## **REMARKS**

**AMENDMENT TO THE DRAWING**

Fig: 6

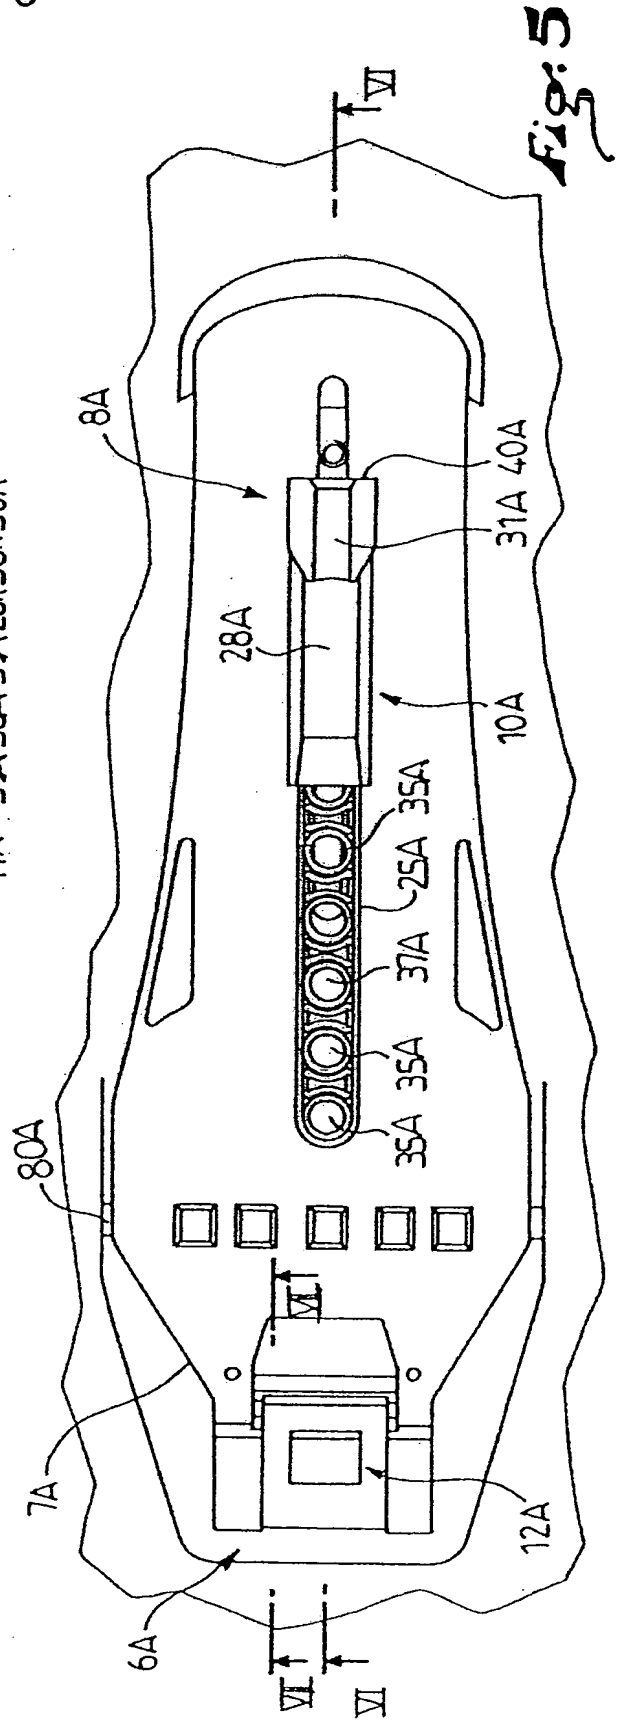
In this section, the Office action objects to paragraph 0032 for referring to boot 11 in Figs. 5-7, whereas Figs. 5-7 fail to illustrate reference number 11.

In the Replacement Sheets of drawing, in response to this objection, reference numeral 2 in Fig. 6 has been changed to "11." Accordingly, reconsideration and withdrawal of the objection is kindly requested.

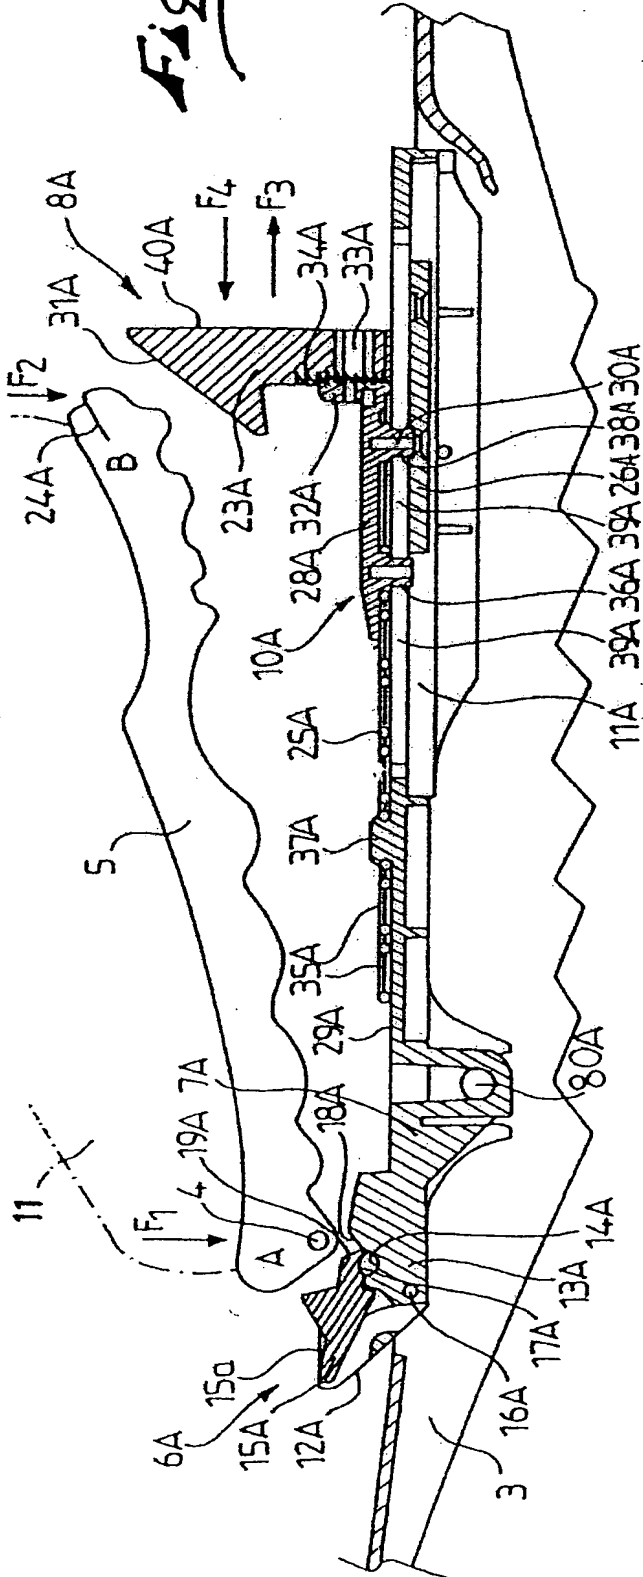
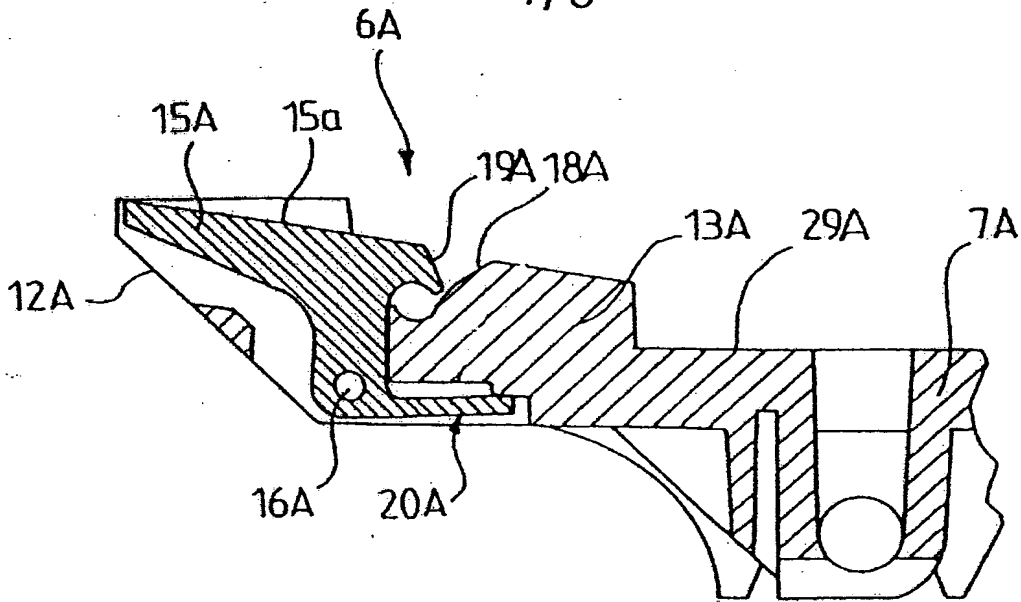
In Section 10 of the Office action, on page 6, the Examiner remarks that “[i]t is unclear why reference number 15A on Figure 6 does not appear to resemble reference number 15A on Figure 7.

In response, Applicants direct attention to Figs. 6 and 7 being two sectional views taken along two different parallel planes (see Fig. 5), which is believed to account for any significant difference in the appearance of element 15A.

*Fig. 3b*

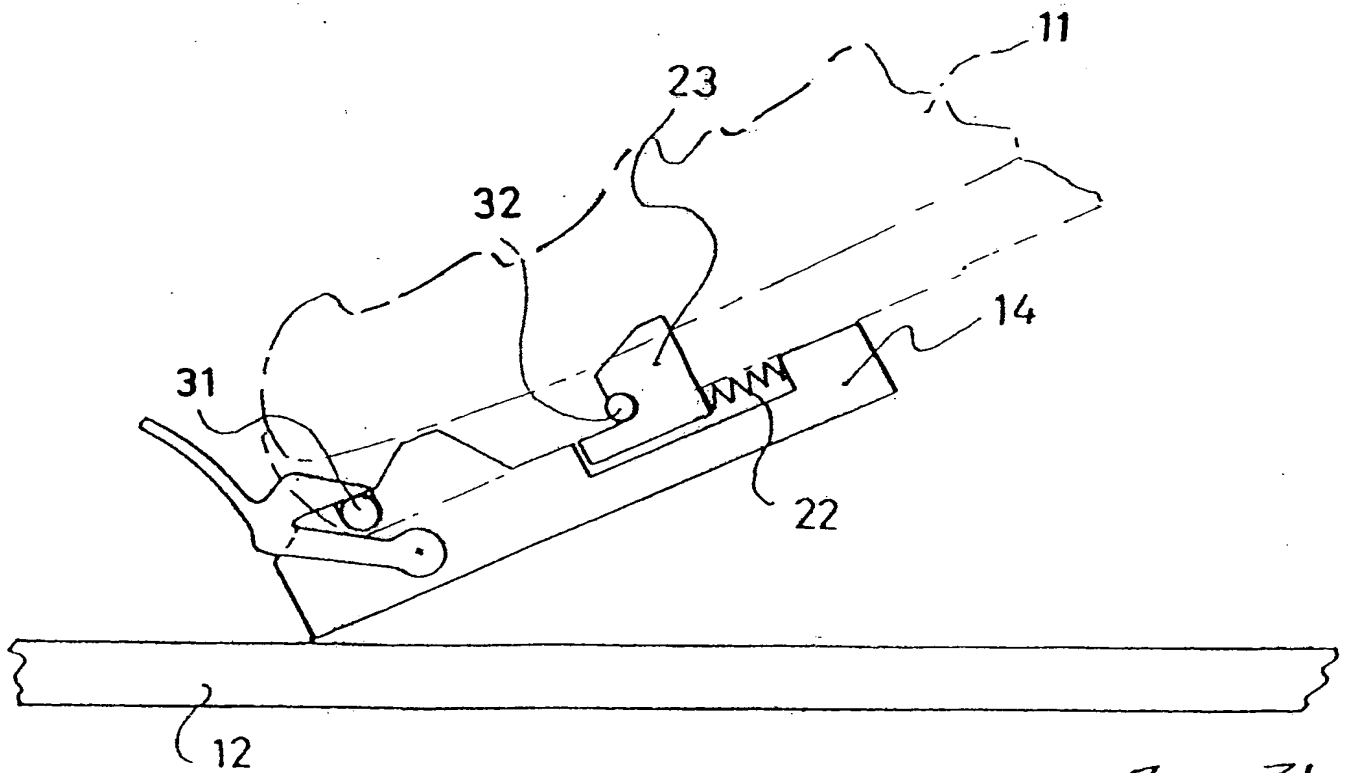
**a. Linkage Member Movable Between Low and High Positions, as in Claims 1 and 12**

First, regarding the linkage member being movable with respect to the sports apparatus between a low position and a high position, as recited in claims 1 and 12, Applicants have added new Fig. 3b to depict the "high position," consistent with the original disclosure, including paragraph 0018 of the specification. In addition, paragraphs 0015 and 0016 have been suitably amended to refer to Fig. 3b. No prohibited new matter has been added.

For the purpose of emphasis and clarification, in the Replacement Sheets of drawing attached hereto, Applicants have relabeled original Fig. 3 as Fig. 3a, showing the boot in the "low position" specified in claim 1, and they have added new Fig. 3b, otherwise a duplicate of Fig. 3a, but showing the boot in the "high position" specified in claim 1.

New Fig. 3b, therefore, shows in a schematic way, *i.e.*, in a way that is intended to encompass a variety of connections, that the linkage member can be movably mounted relative to the base to a “high” position, Fig. 3a showing the linkage member in the “low” position.

*Fig. 8*

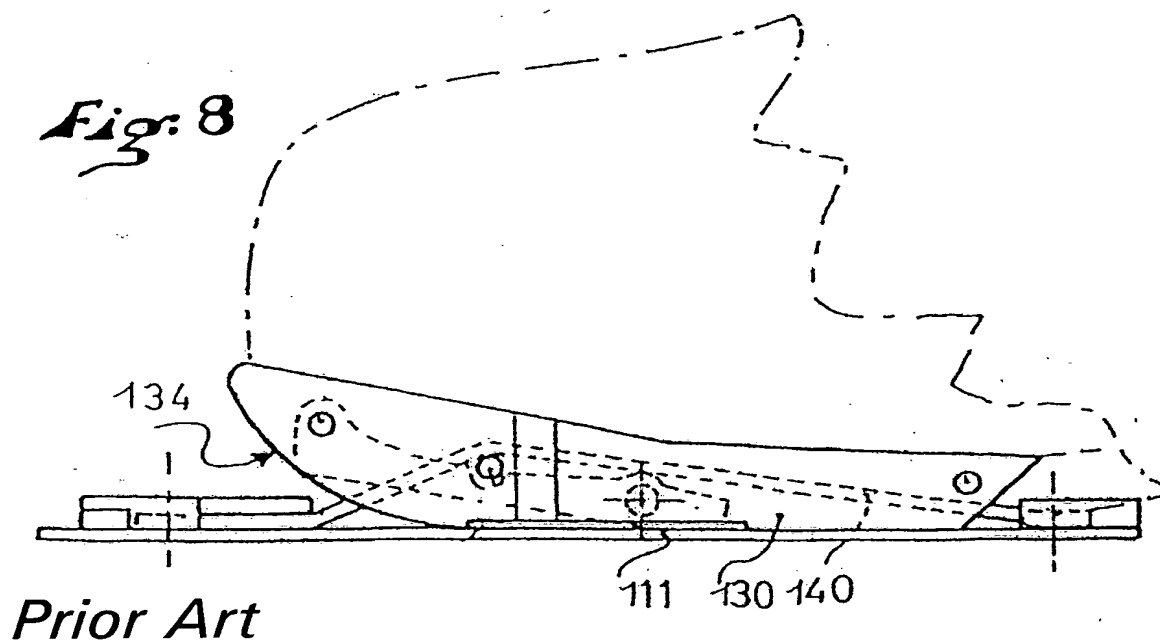
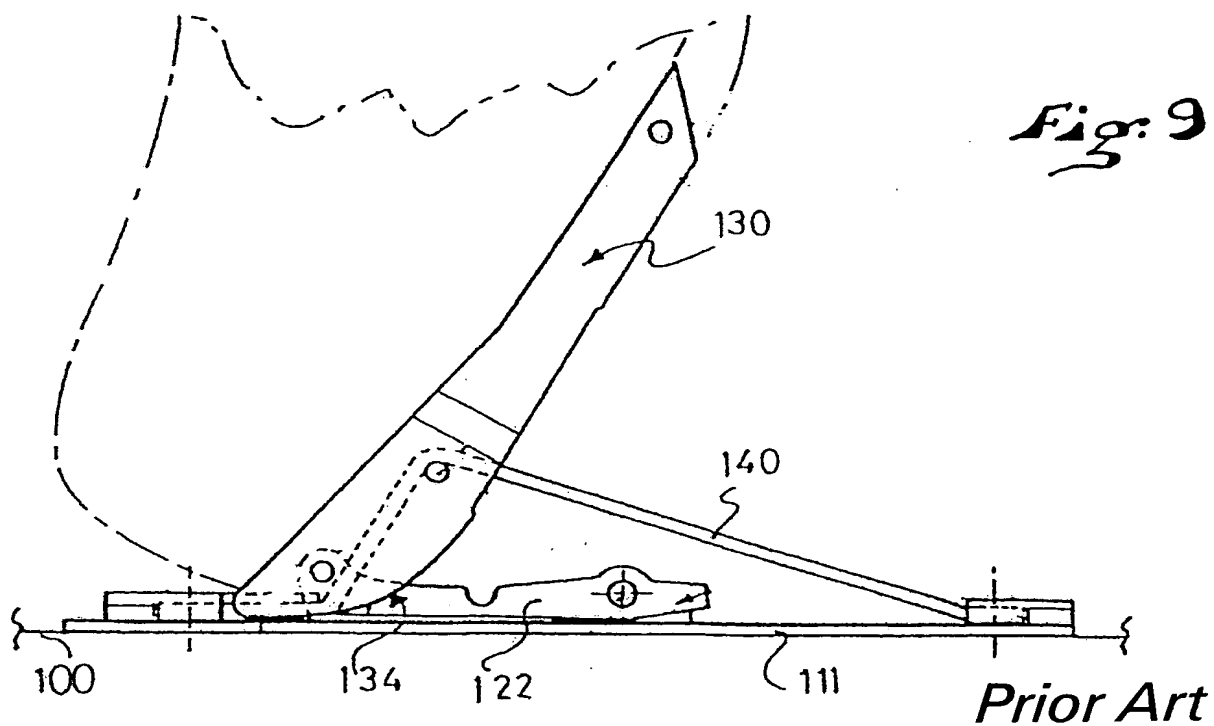
"the 'linkage member' reference number 14 of Figures 1-4 appears to be fixed to the base of the 'sports article,' whereas the linkage member 130 of Figs. 8, 9, and the linkage member 203 of Figs. 10, 11, appear to be fixed to the boot and not to their respective sports articles 100, 214.

In response to the objection under 37 CFR §1.83(a) for allegedly not illustrating a “convex surface,” as specified in claim 12, Applicants direct attention to element 134 of Figs. 8, 9.

In response to the objection under 37 CFR §1.83(a) for allegedly not illustrating a “connecting rod,” as specified in claim 11, Applicants direct attention to element 122 of Figs. 8, 9 and elements 216-219 of Figs. 10, 11.

Accordingly, the original drawing shows such convex surface and, therefore, reconsideration and withdrawal of the objection under 37 CFR §1.83(a) is kindly requested.

Still further, and with regard to the comments appearing in paragraph (C) of the rejection, linkage member 130 of Applicants' Figs. 8 and 9 is connected to **both** the boot and the sports article 100 (the latter via the base 111), as would be the linkage member 14 if it were to incorporate the mechanism of Figs. 8 and 9.

Still further, to answer the Examiner's question at the top of page 8 of the Office action, viz., "it is also not apparent what the convex surface set forth in claim 12 is," the convex surface is element 134, for example, described in Applicants' paragraph 0018 and shown in Figs. 8 and 9 (taken from the aforementioned U.S. Patent No. 6,499,761, the disclosure of which is incorporated by reference in Applicants' specification), which

provides for a “rolling effect” for the linkage member as it moves relative to the sports article 100 between high and low positions, as explained in paragraph 0018.
